Attached are SNC written responses to NRC questions on the open phase commitment change, to be discussed at a future public meeting.

**Subject:** RE: Questions on Open Phase Commitment Extension

## Response to NRC Questions Regarding SNC's Supplemental Response to Bulletin 2012-01, Design Vulnerability in Electric Power System

Figure 8.2-201  
Offsite Power System One-Line Diagram

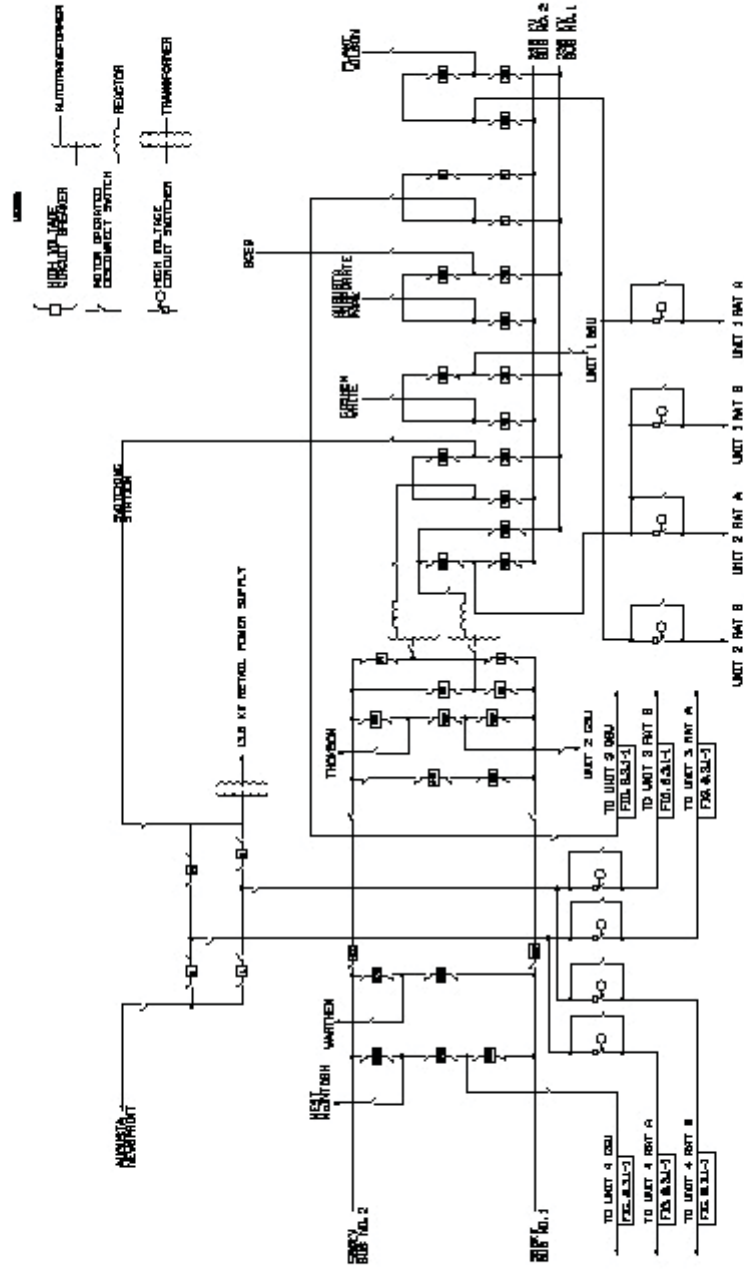
*Q2. Since Vogtle 1&2 will implement open phase detection and alarm by the end of 2018 and Vogtle 3 shares a 230/500 kV switchyard with Vogtle 1&2, and Vogtle 4 is connected to a 500kV switchyard, what information is needed before implementing the open phase detection and alarm. Is data being gathered during operation before implementing the open phase detection and alarm*

With regard to shared features of the Vogtle switchyard, the existing Vogtle 1 and 2 switchyard consists of a 230kV section and 500kV section. The sections are connected by 230/500kV autotransformers. Unit 1 output is connected to the 230kV section and Unit 2 output is connected to the 500kV section. Both Unit 1 and 2 GDC 17 offsite power sources are supplied from the 230kV section.

Unit 3 output will be connected to the 230kV section of the existing switchyard. Unit 4 output will be connected to a new 500kV switchyard. The new 500kV switchyard is connected to the 500kV section of the existing switchyard by overhead tie lines. The tie line connections effectively make the new switchyard an extension of the 500kV section of the existing switchyard. Refer to Vogtle 3 and 4 UFSAR Figure 8.2-201 (below).

The request to revert the commitment completion date back to the end of each Unit's second maintenance/refueling outage was not solely based on a need to collect information. Vogtle Units 3 and 4 are still under construction, and as such, there is no switchyard data to collect. SNC concluded that it would be prudent to observe industry initiatives and lessons learned and to have some period of operation wherein station performance could be assessed, prior to performing detailed analyses of the effects of an OPC on the **AP1000** design.
